February 14, 2023 - Design Review Meeting #10

Meeting Summary

Project: Arlington Avenue Bridges	Date: February 14, 2023 1 PM
Topics: <ul style="list-style-type: none"> • Review Existing Bridge Railings and Sidewalks in Surrounding Area Context • Review Proposed Arlington Bridge and Pedestrian Fencing/Railing Materials, Colors, and Finishes • Review Arlington Bridge Sidewalk Paving Patterns, Colors, and Finishes • Schedule • Open Discussions/Discussion 	Location: Virtual - Microsoft Teams Meeting

5. Concrete Colors

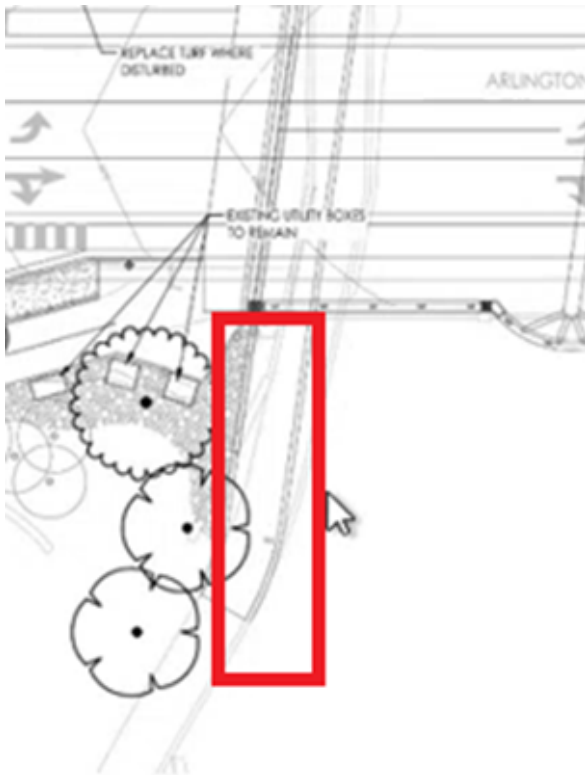
- a. Jeffrey Grob asked, and Barb Santner said that the concrete would come from a single source manufacturer. Khalil Wilson indicated that the design standard details included a test strip from the concrete manufacture to do color matching. Barb Santner confirmed those standard cut sheets are included in the plans.
